Final Initial Study/Mitigated Negative Declaration

LS Power Grid California Manning 500/230 Kilovolt Substation Project

June 2025

Project Element Map 10 of 23

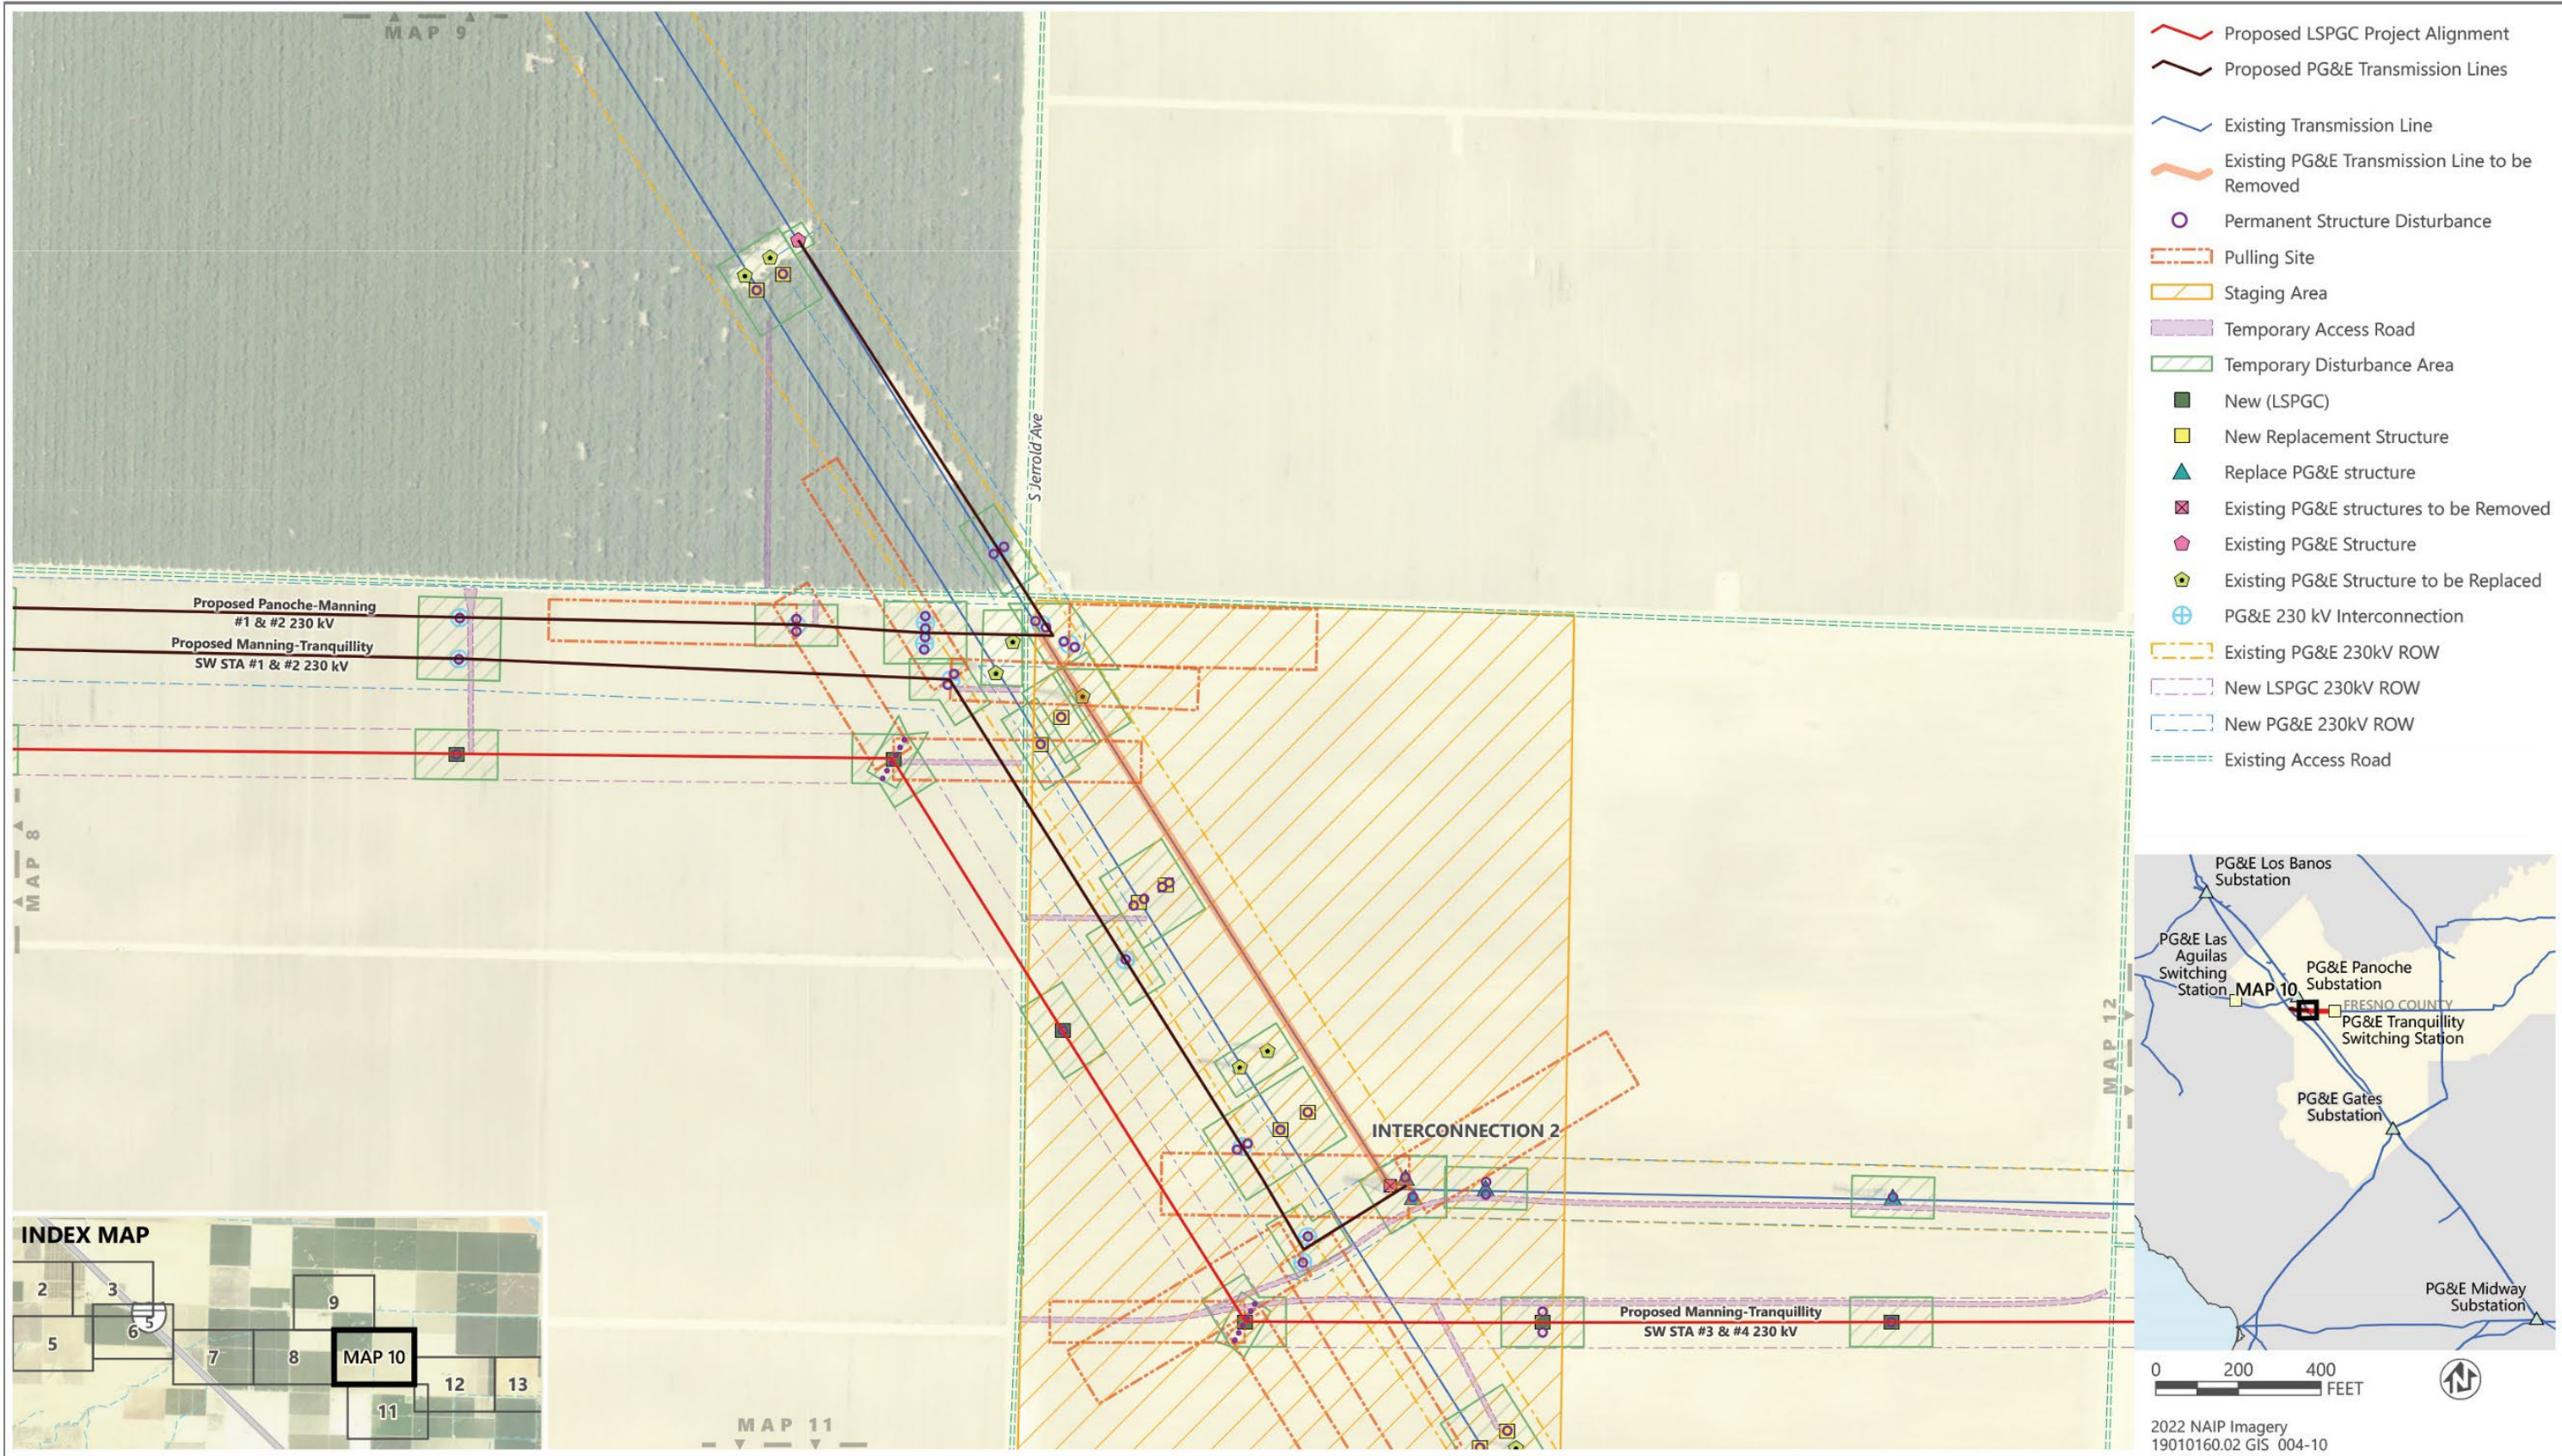
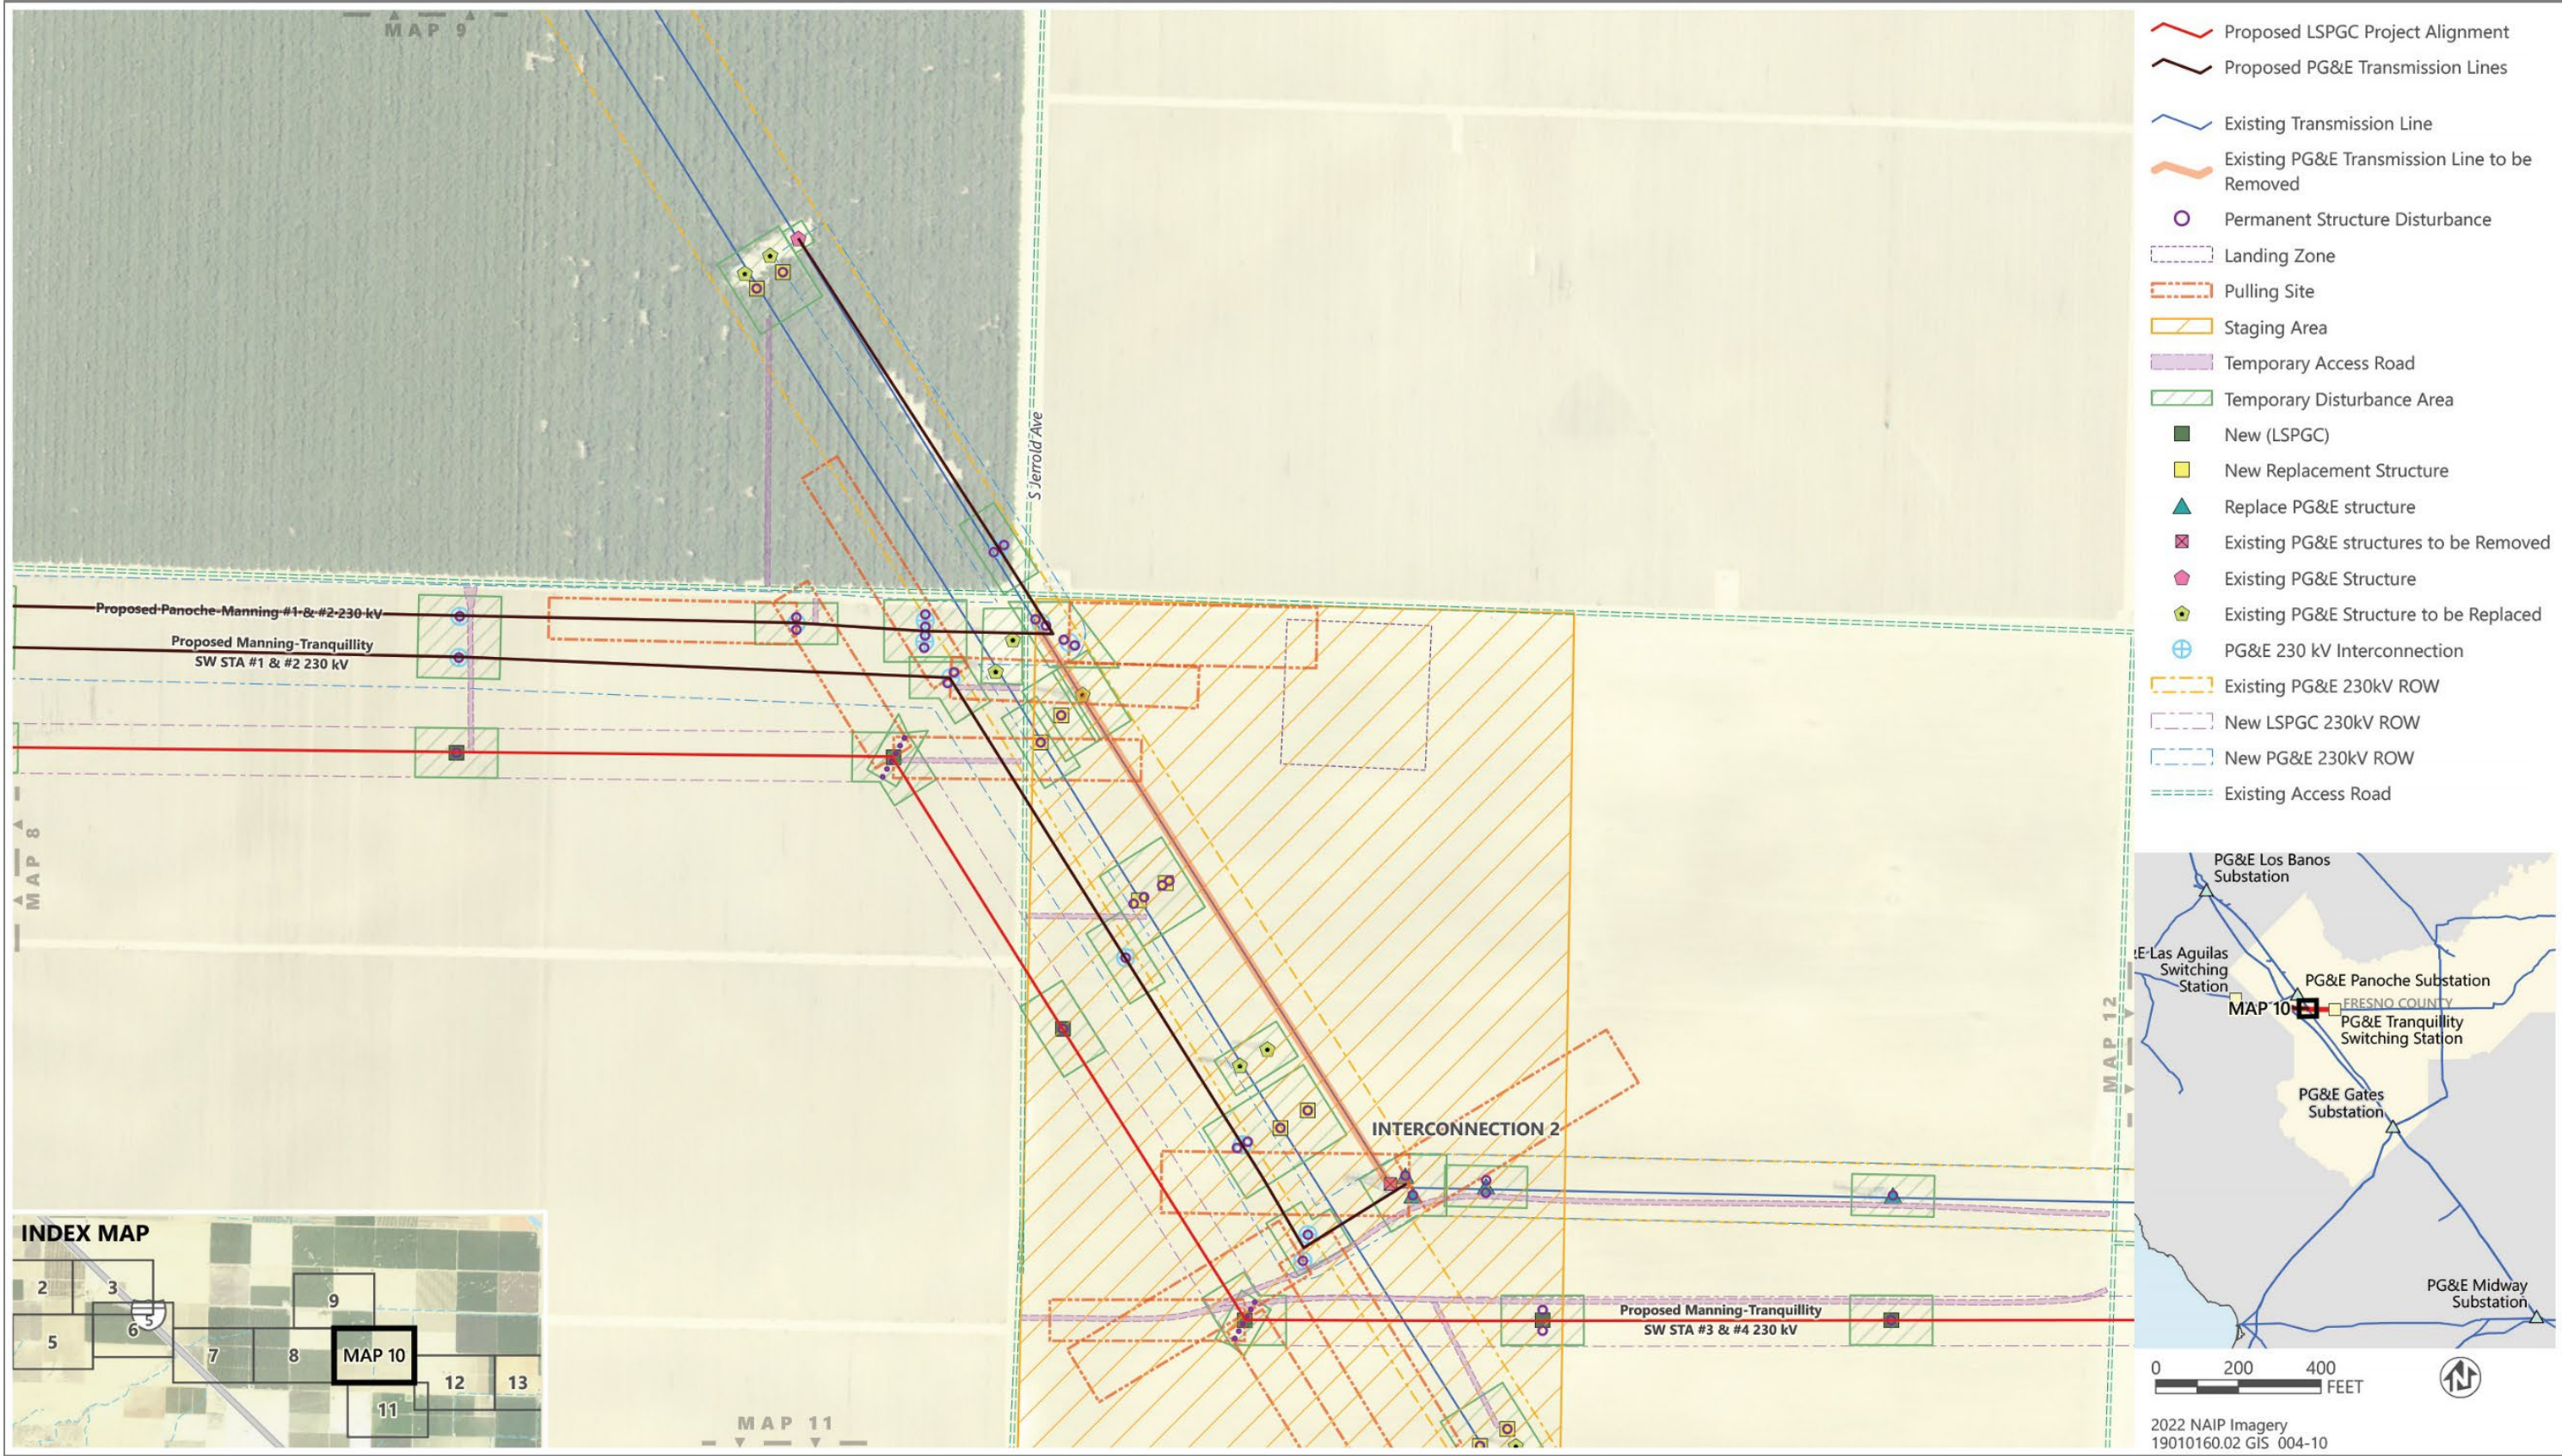
In response to Comment O1-15, revisions have been made to Project Element Map 10 of 23 on page A-10 of the Appendix A to Appendix 1:
